LET národní podnik KUNOVICE

OPERATING BULLETIN No. L 13/025

**Re:** Inspection and eventual replacement of control rods eyes on the sailplane L 13 - from the 1st series up to the 14th sailplane of the 34th series.

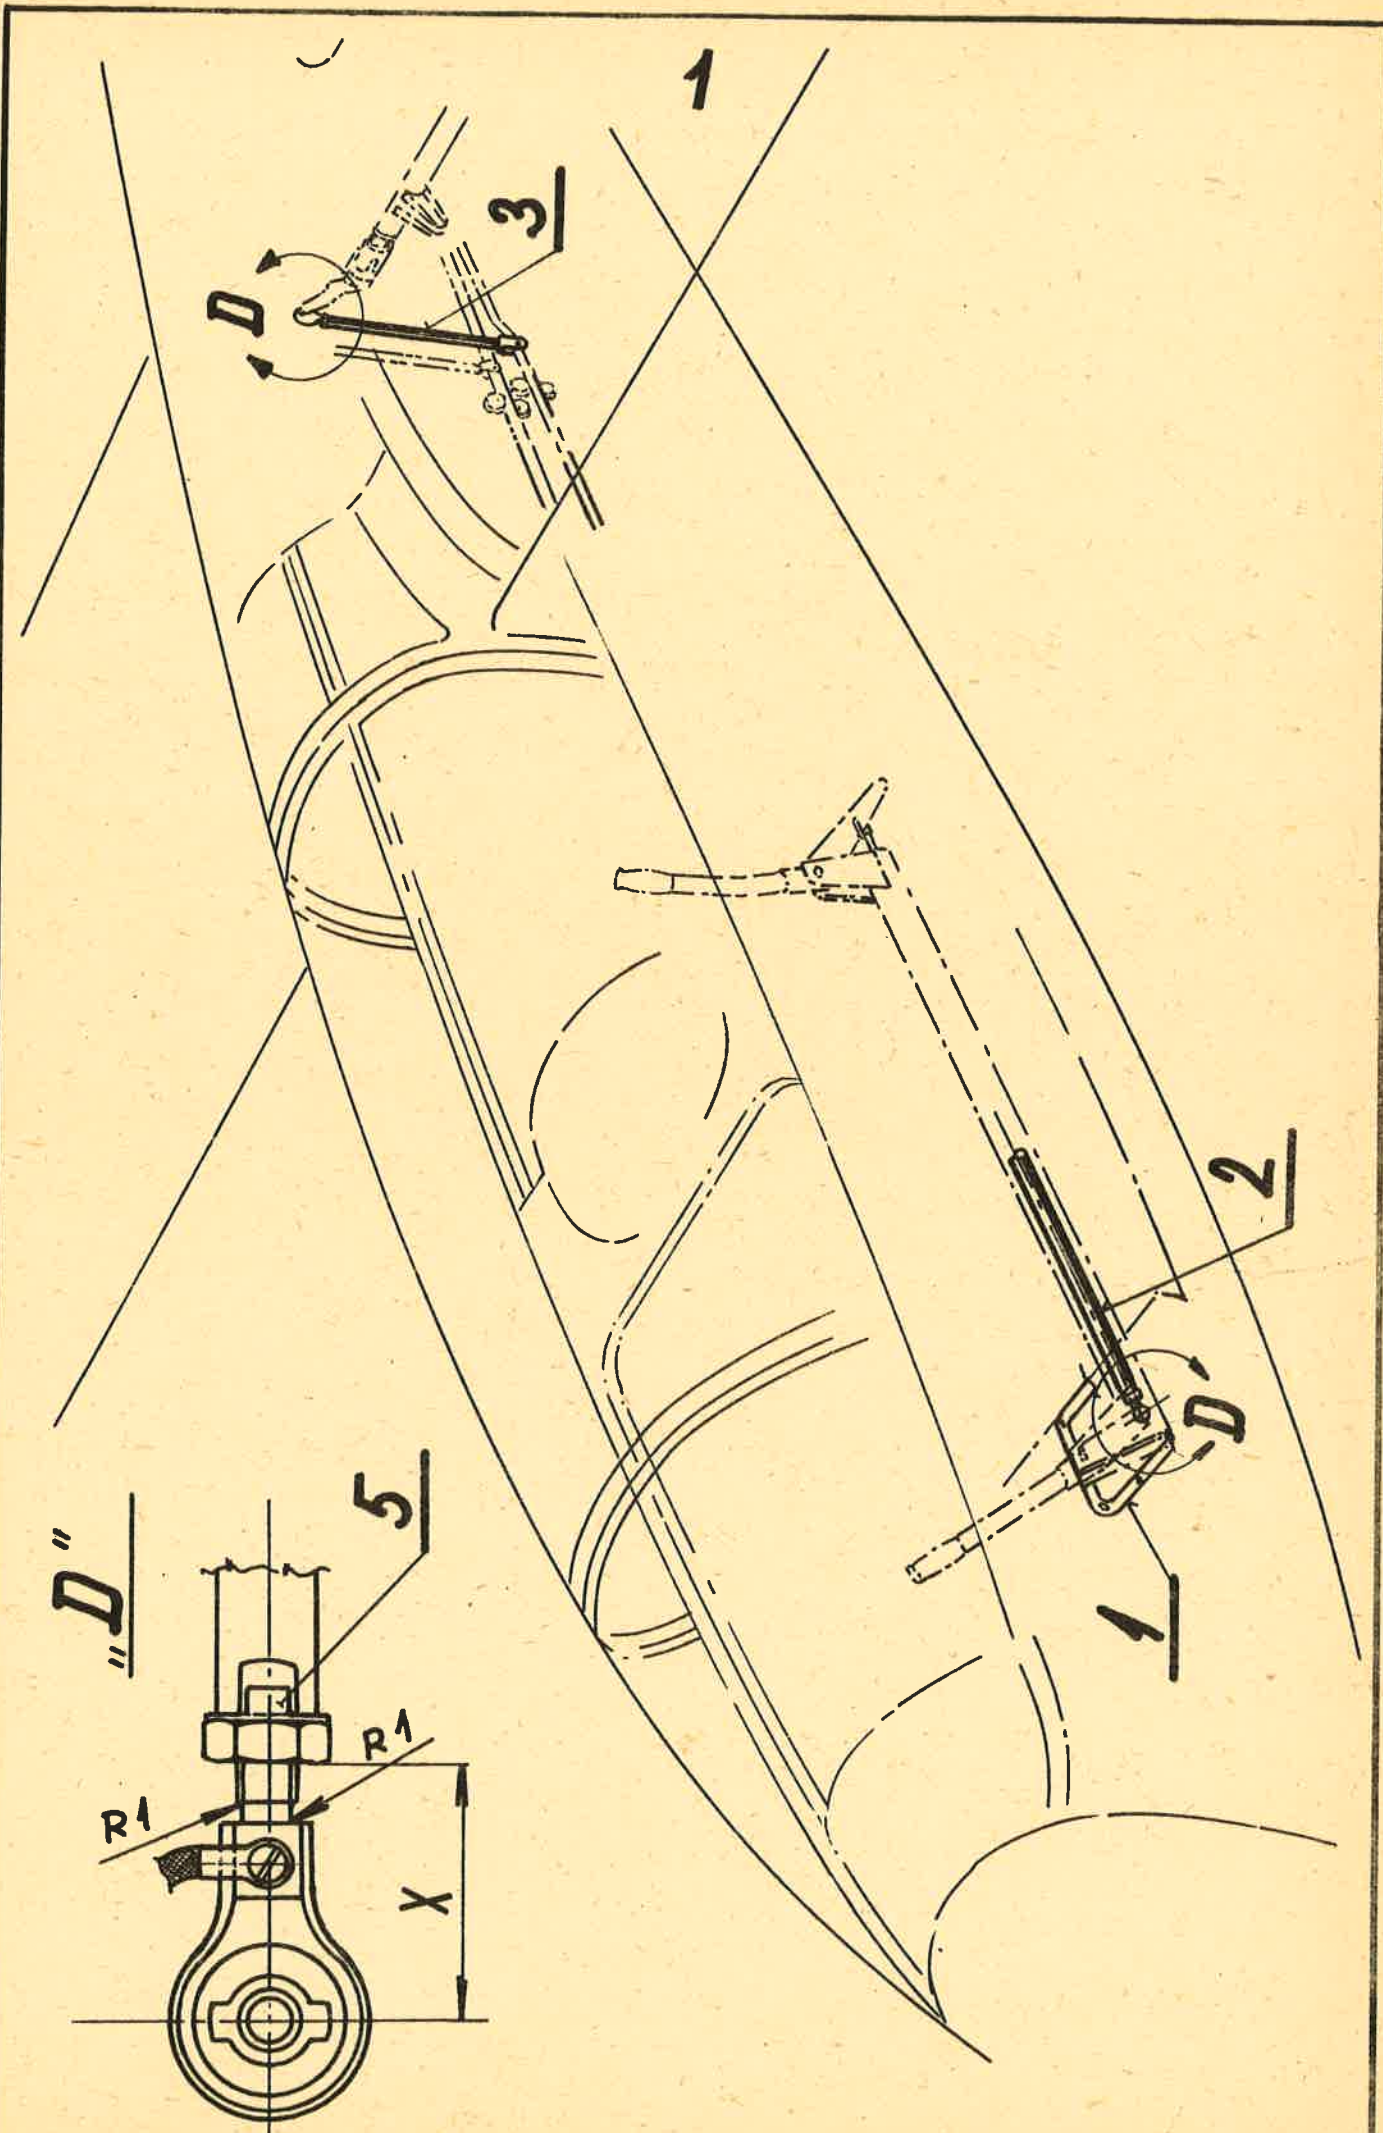
Remove the frame and the floor fabric cover of the front control stick (See pos. 1). Check the eye of connecting control rod (pos. 2), if the radii of recess on the eye corresponds to the radii R1, shown in detail on Figure "D". The same procedure is to be followed with the interceptor control rod in fuselage (pos. 3), and wings - near the rib No. 15 (See Figure 2, view "A", pos. 4).

If the eye is screwed to the stop so that the nut covers the recess, it is to be unscrewed from the rod and properly checked (partial eye turning might be sufficient for inspection, but with regard to the lock washer pos.5, Fig. 1, detail "D" which cannot be re-used, it is necessary to remove the eye completely).

Note: In order to avoid re-setting of control rods due to the inspection and replacement of eyes, it is recommended to measure the distance X, shown on the Fig.1, detail "D", and then screw and safeguard the replaced eyes accordingly.

Report to the Technical Service Dept. of the Manufacturer that will supply new eyes for replacement free of charge, if any of the radii is smaller than R1. Inspection and replacement may be carried-out by a semi-skilled worker of the Operator.
